工程名稱：將軍澳日出康城 11

工程項目：試水箱 單元件 安裝過程中 comment

PROPOSED RESIDENTIAL
DEVELOPMENT AT TKOTL 70RP,
PHASE 11. LOHAS PARK, TSEUNG
KWAN O. N.T.

PMU Inspection Report 01

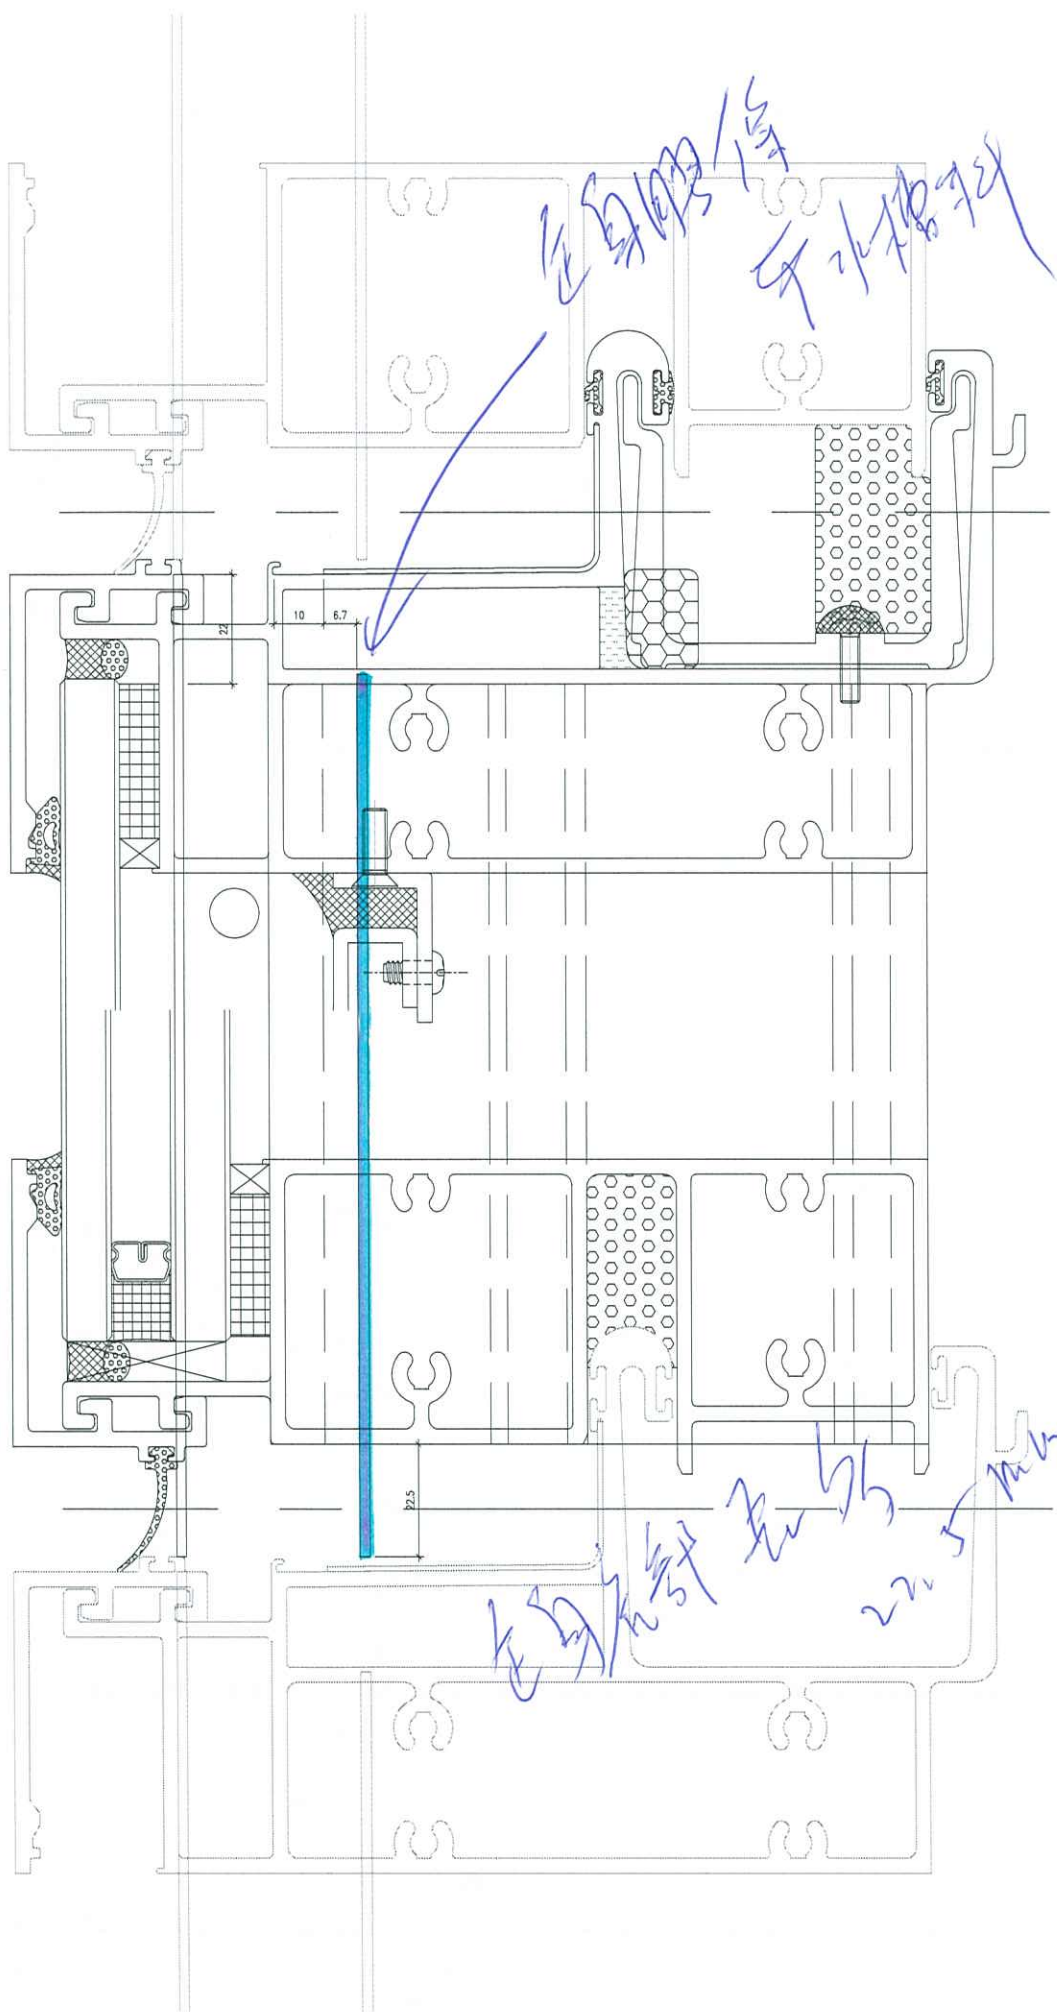
企料企身膠條不
夠高，底不夠長

單元件中
橫位置有
方孔

飾線
Capping 封
孔

工程號	J858	類別		物料號	-				
地盘	康城11期	制圖	W. E. X	2022-05-30	圖號	X86255-P01R			
修改		採用工廠	地盘 -	图纸名称	铝固定码加工图	復核	-	數量	24
日期		材料颜色	CHROMATE	材料	X86284	批准	-	單件重量	- (KG)

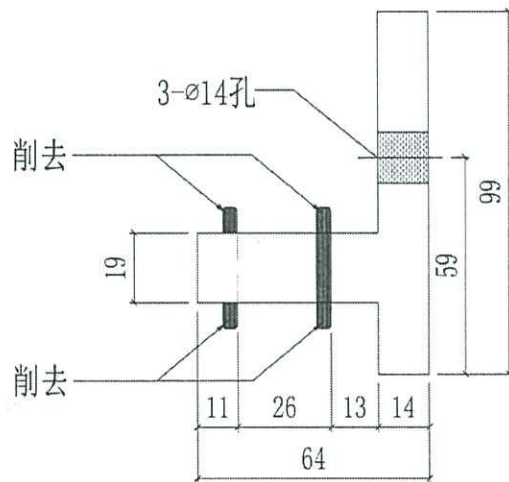
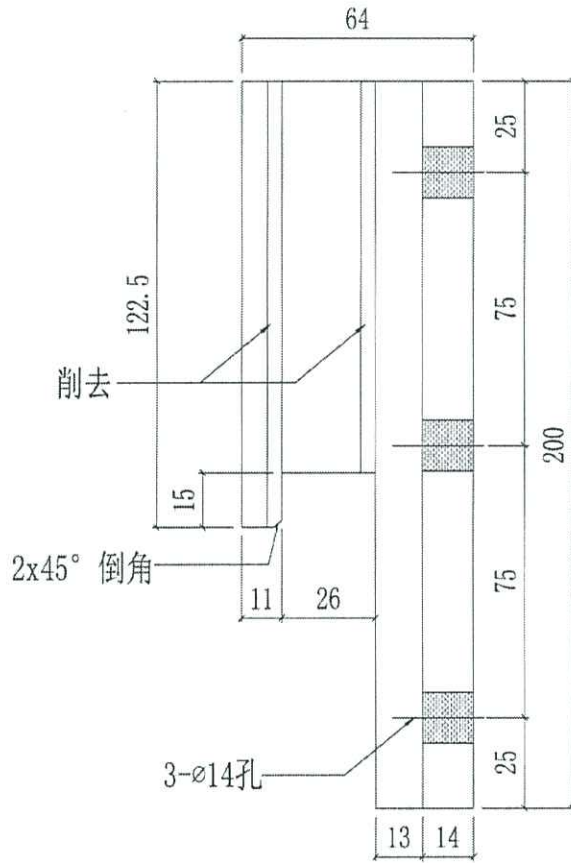
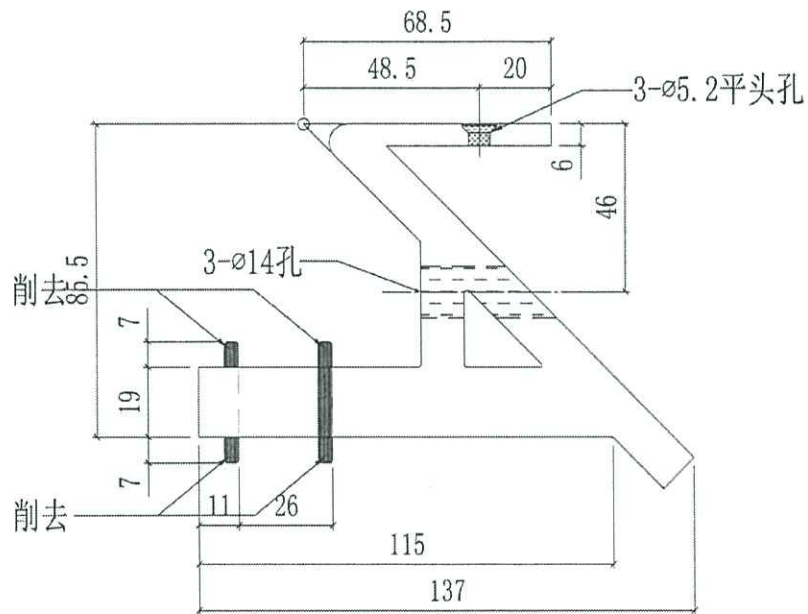
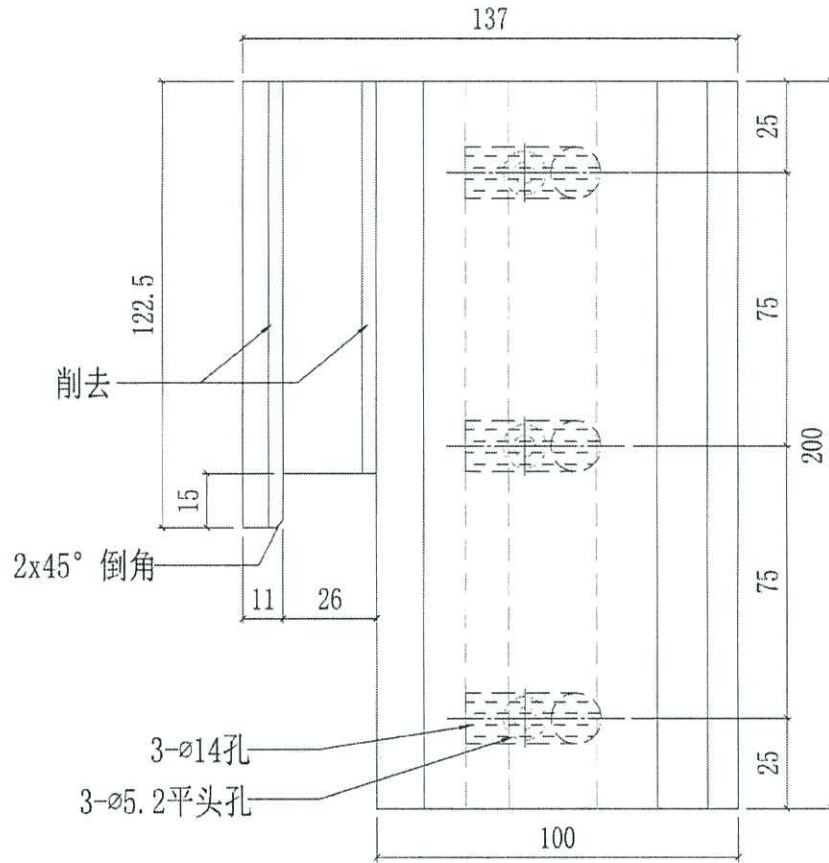
1. 顧問 comment 要有橫向移動，削去魚骨
拆圖按此改大貨。

請按加工圖生產單元掛勾碼送試水場，試水場地址在 EI 4672 (合共 28 隻)

1 HORIZONTAL DETAIL
CD08 CURTAIN WALL

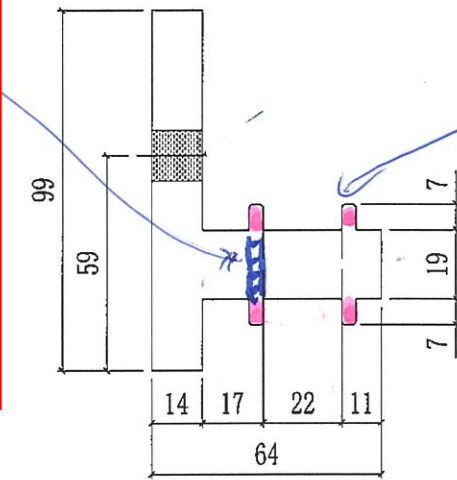
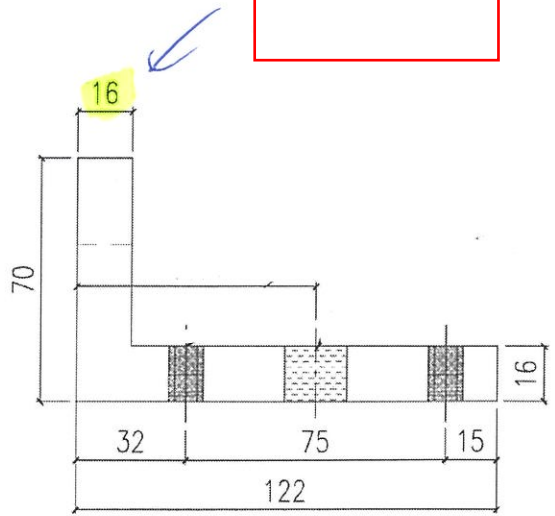
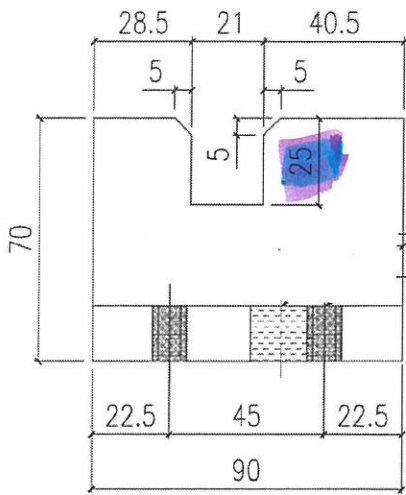
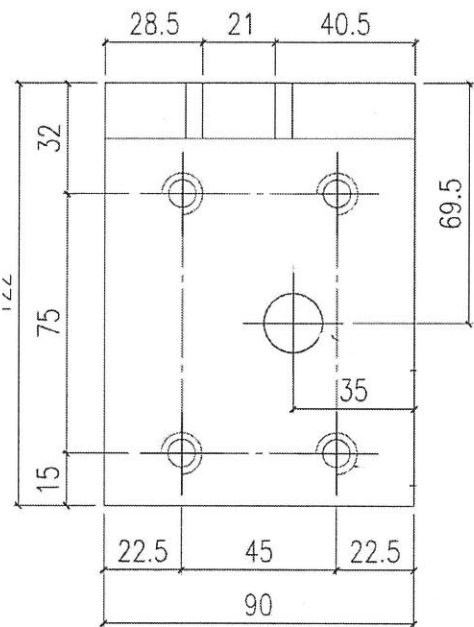
2022/12/26 試水場現場安裝增加 movement 回覆。

#2 Hatch單元件
掛勾加開
至26mm寬

#1 魚骨前去
單元件叉碼的
高度

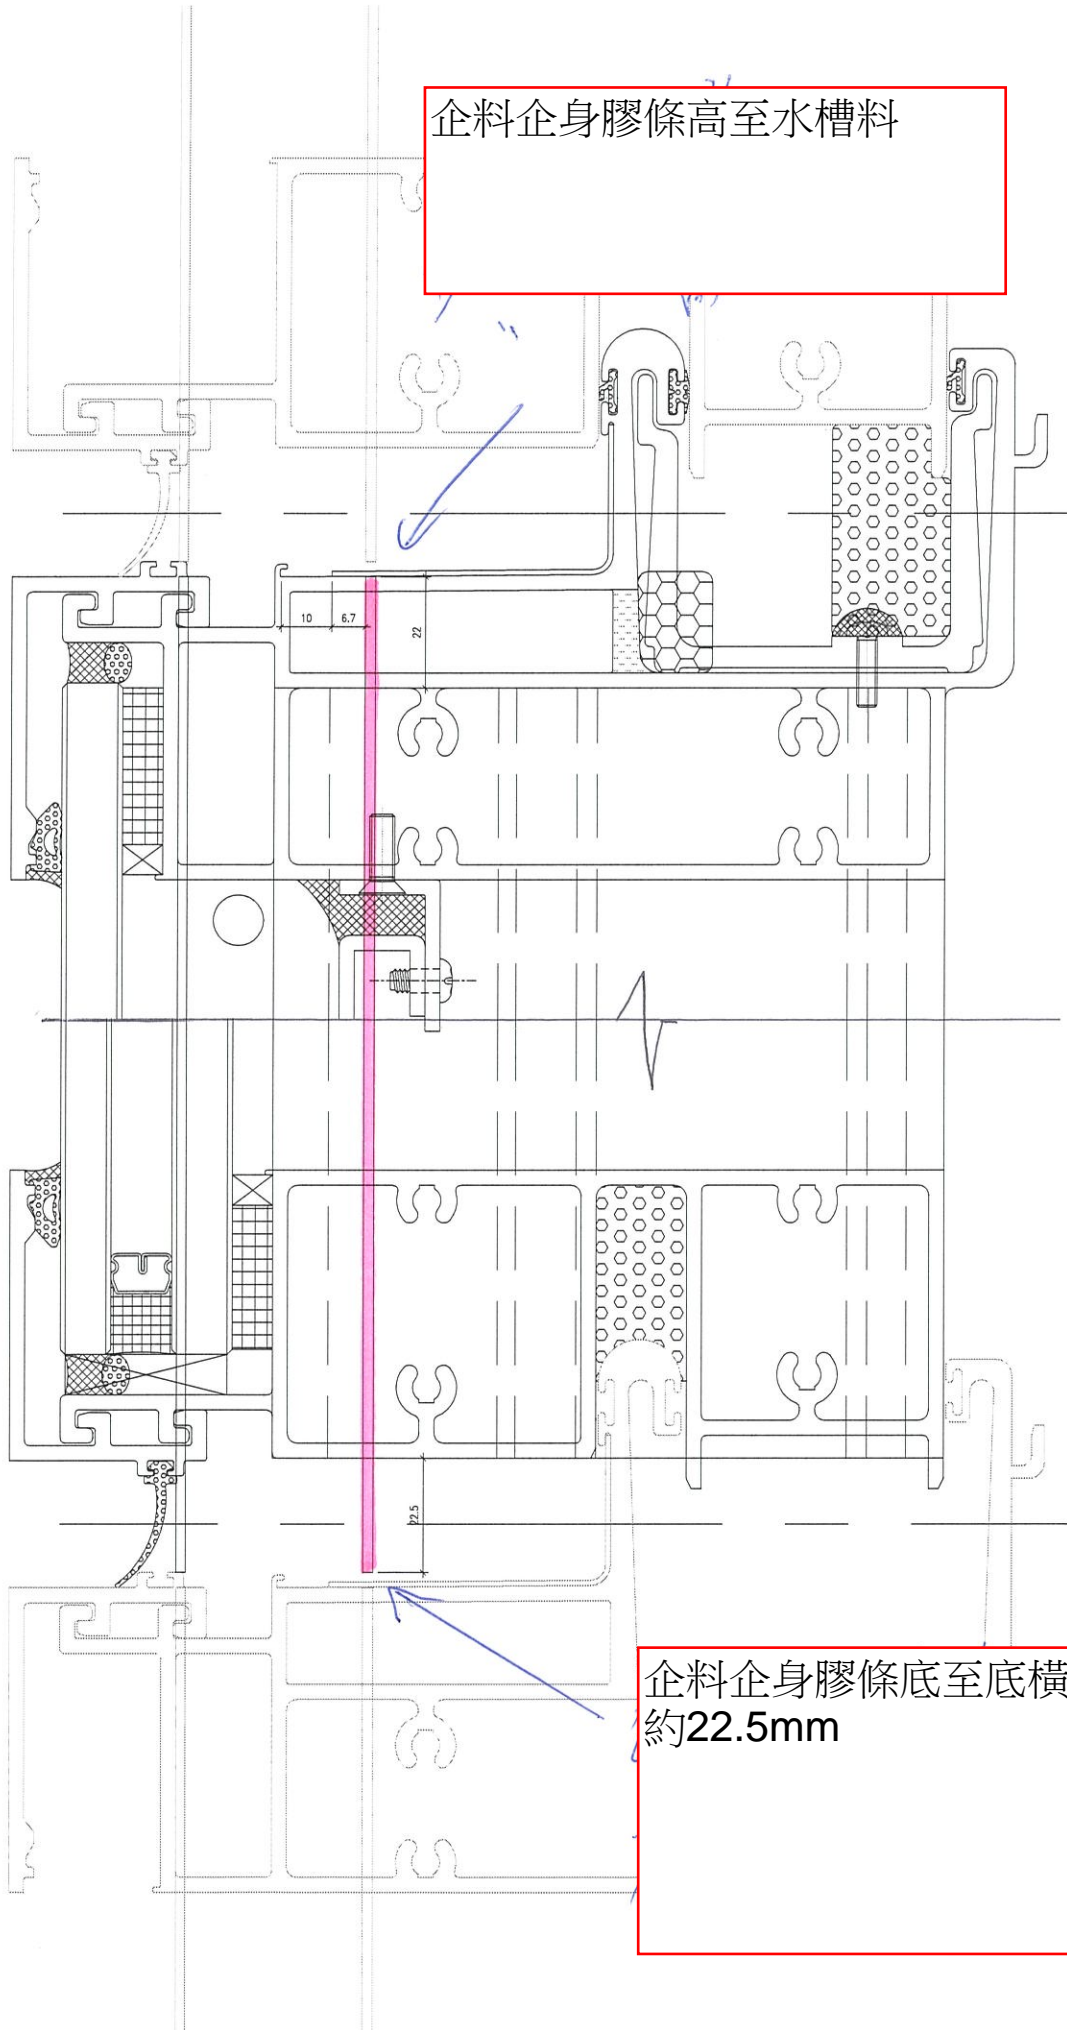
企料企身膠條高至水槽料

企料企身膠條底至底橫
約22.5mm
